**AGENDA**  
**PLANNING COMMISSION OF THE**  
**CITY OF WHITE BEAR LAKE, MINNESOTA**  
**MONDAY, MARCH 28, 2022**  
**7:00 P.M. IN THE CITY HALL COUNCIL CHAMBERS**

**To:** The Planning Commission  
**From:** Samantha Crosby, Planning & Zoning Coordinator  
**Date:** March 28, 2022  
**Subject:** Rose's Park View Addition / 1788 Highway 96, Case No. 22-2-P

**TO:** Samantha Crosby, Planning & Zoning Coordinator

The Engineering Department reviewed the Stormwater Calculations and Civil and Landscape plans (C-000, C-010, C-101, C-201, C-202, C-301, C-501, C-502, C-503, L-010, L-101, and L-501) dated February 14, 2022, Preliminary Plat and Existing Conditions dated February 11, 2022, and received February 15, 2022.

**Note:**

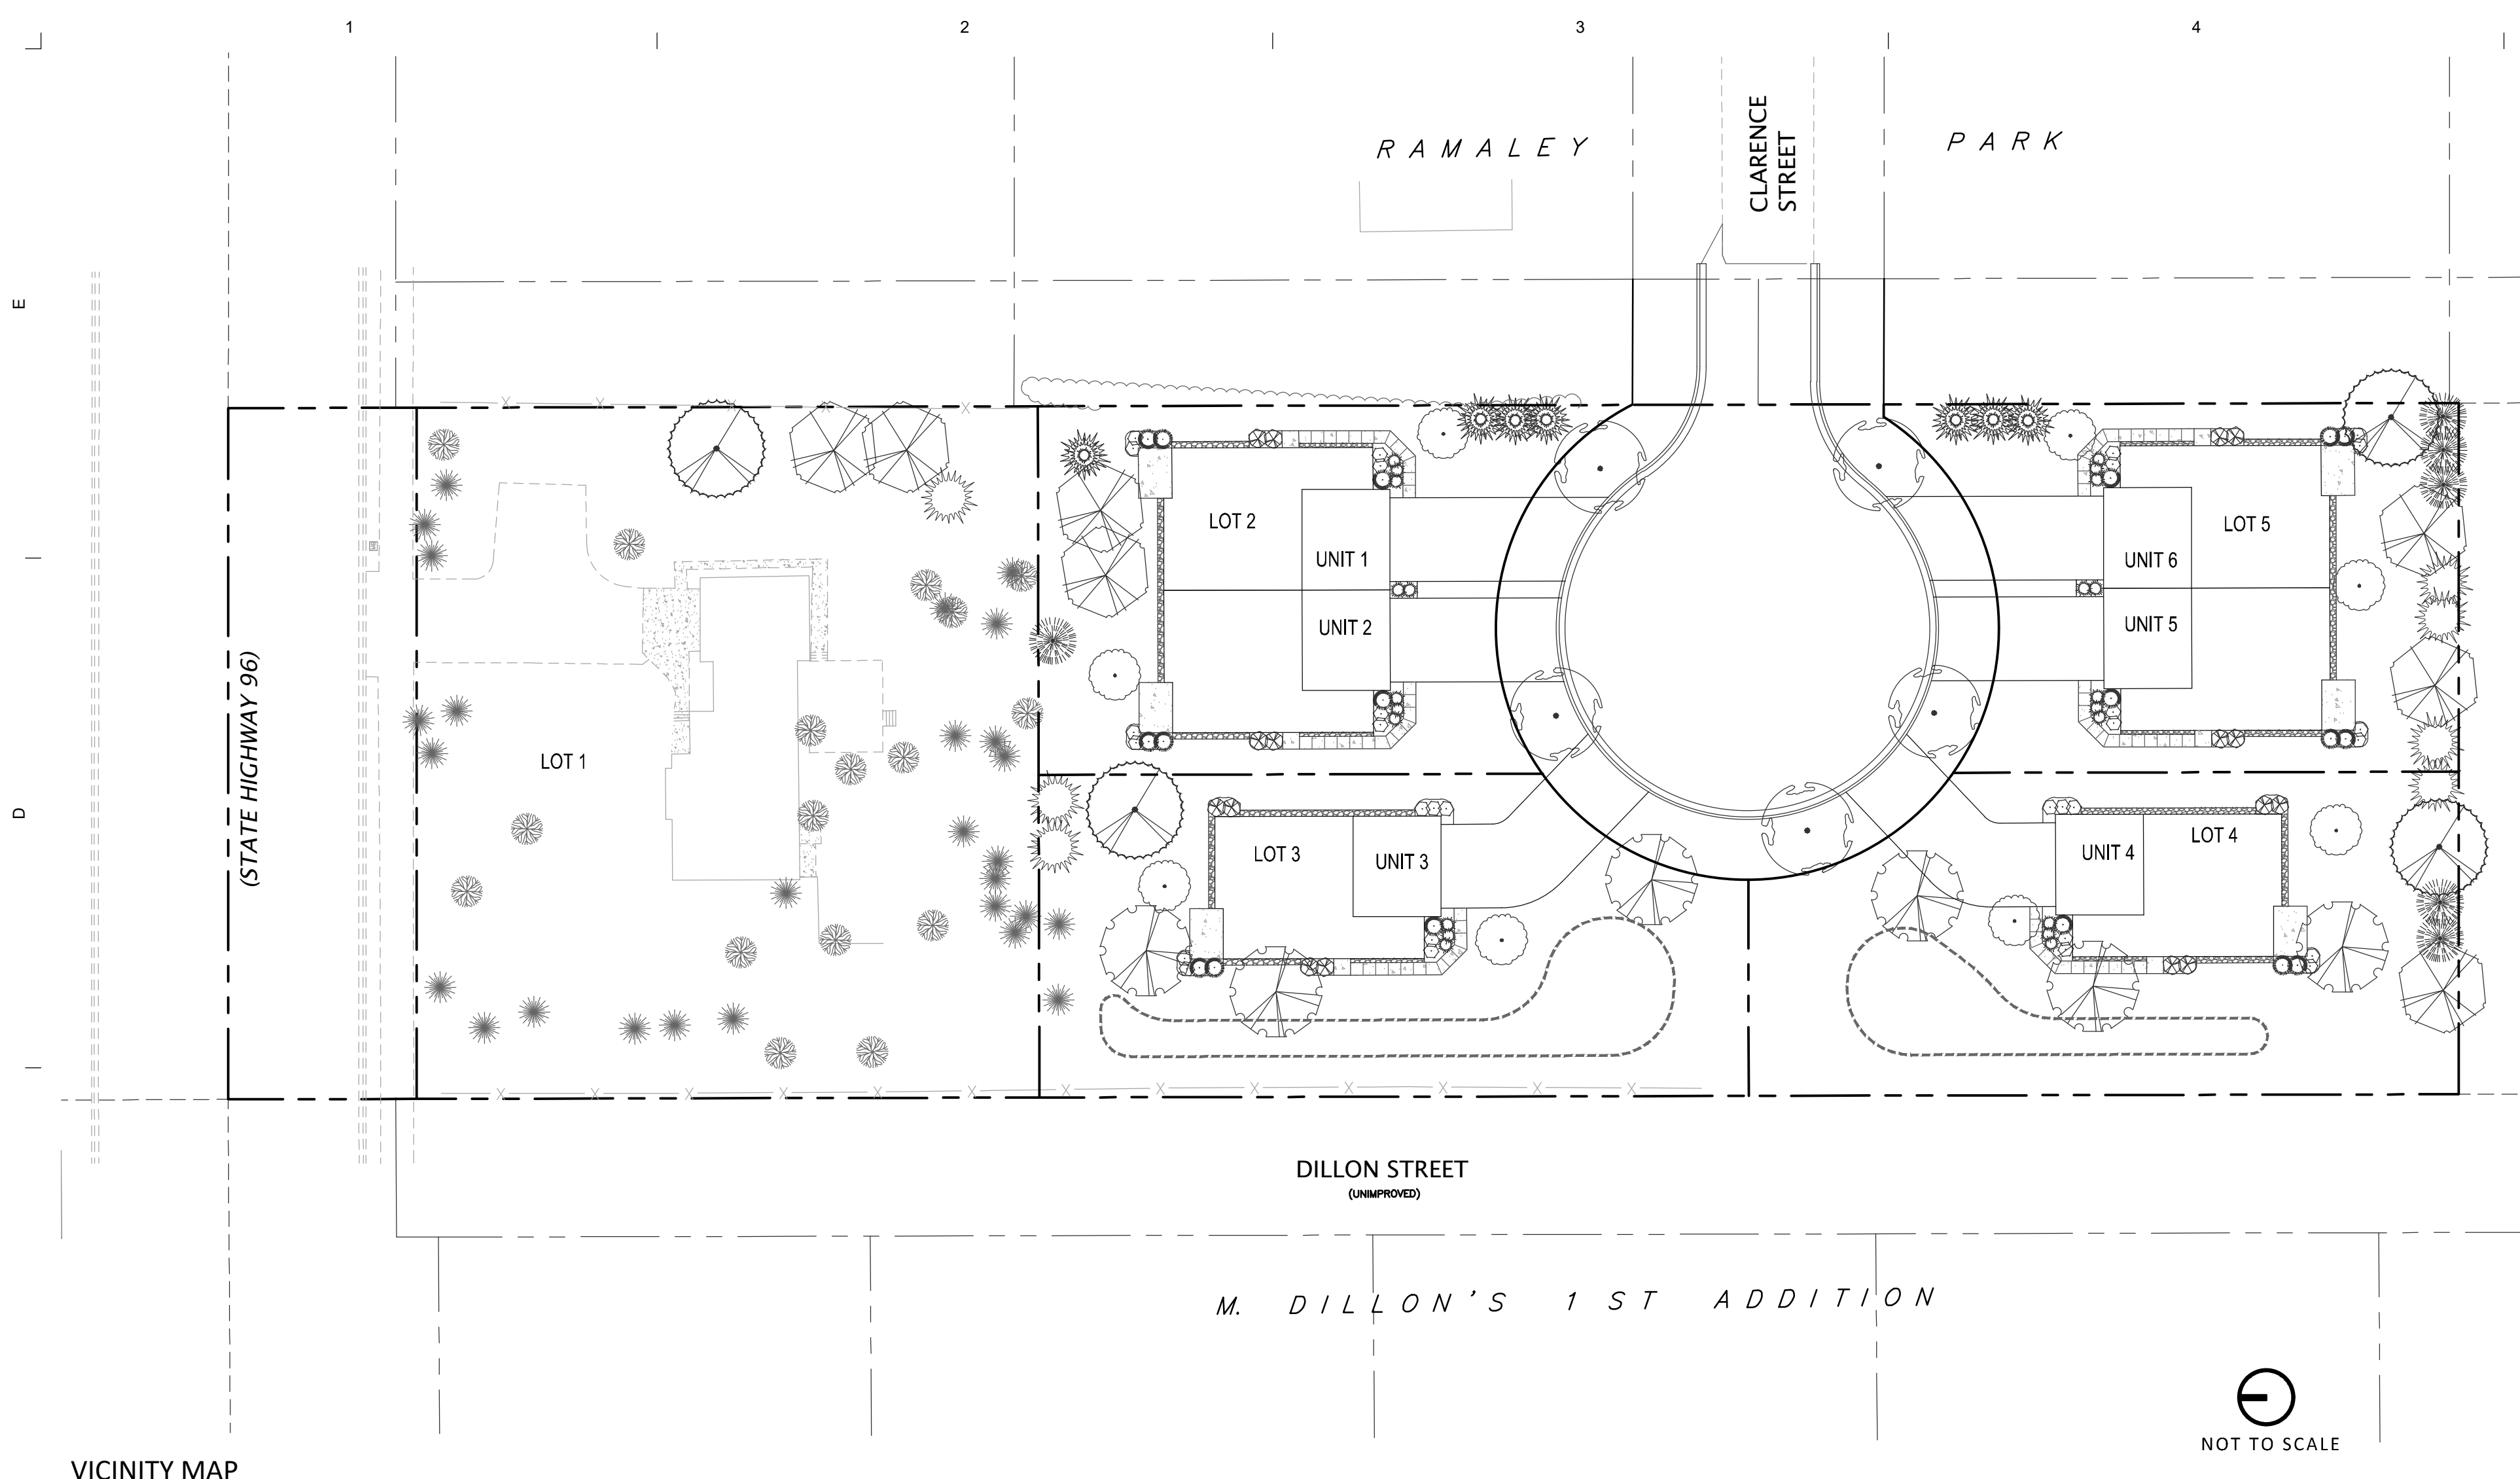
- Permanent infiltration basin monuments shall be installed around the perimeter of the infiltration basin seeded area. Please add the infiltration basin monuments on the appropriate plan sheet(s) at the locations shown on the attached drawing. The City will provide a detail of the monument at a later date for inclusion on the detail sheets.
- The infiltration basin shall be constructed and function as designed. This includes permanently stabilized drainage areas to the basin, removal of any deposited sediment in the basin, uncompacting soils in the basin (both engineered soils and native soils), conducting a soil test to verify that the basin is infiltrating as designed, etc.

12) Please include native seed in the areas highlighted on the attached drawing.

UTILITY PLAN  
**C-301**

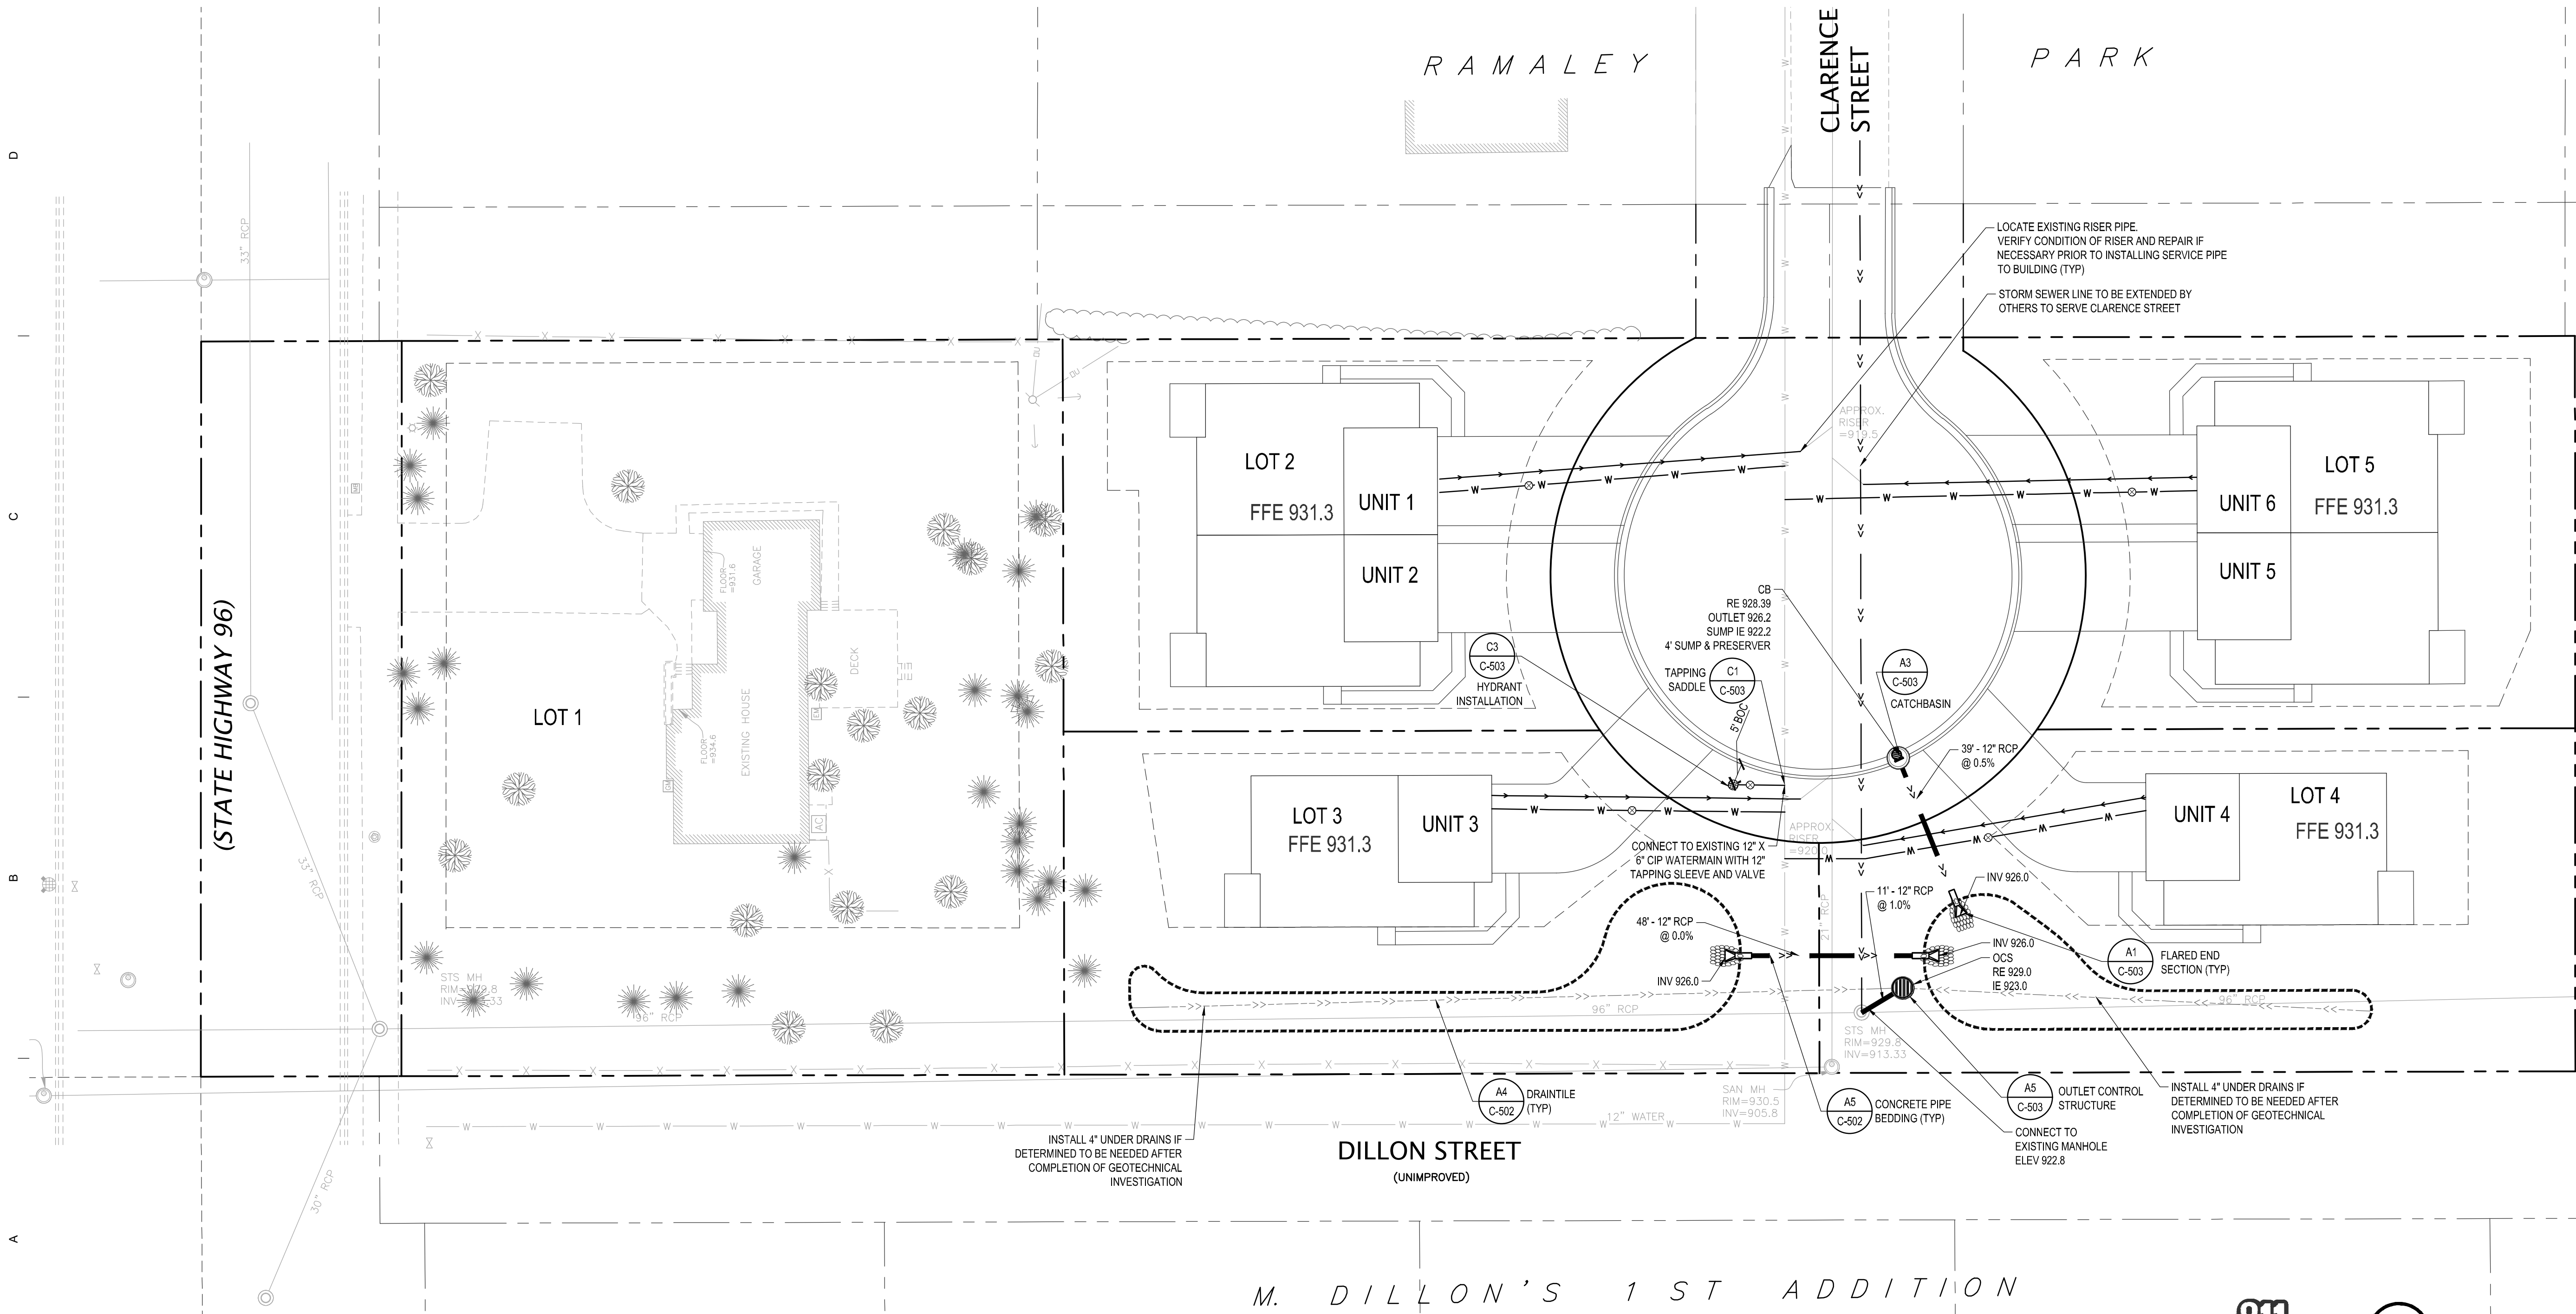
- 8) Infiltration basins are meant to capture and infiltrate the required water quality volume only (see related comment 20). An outlet shall be provided for any additional volume captured in the basin that is above the water quality volume. This outlet(s) can consist of smaller orifices or other methods to reduce flow in order to meet rate control requirements. Revise the HydroCAD model, and detail A5 (outlet control structure) to meet these requirements. This comment should be revisited once the Geotechnical Report is available and the soil types are identified.

- 9) The primary outlet for pond 5P in the proposed conditions model is at an elevation of 929.10. Please revise the utility plan to be consistent with the model.

- 10) Detail C1/C-503 referenced on the Utility Plan (C-301) for the hydrant connection is for water services. A wet tap is acceptable for the hydrant tee, but no detail reference is necessary. Please remove the detail note.
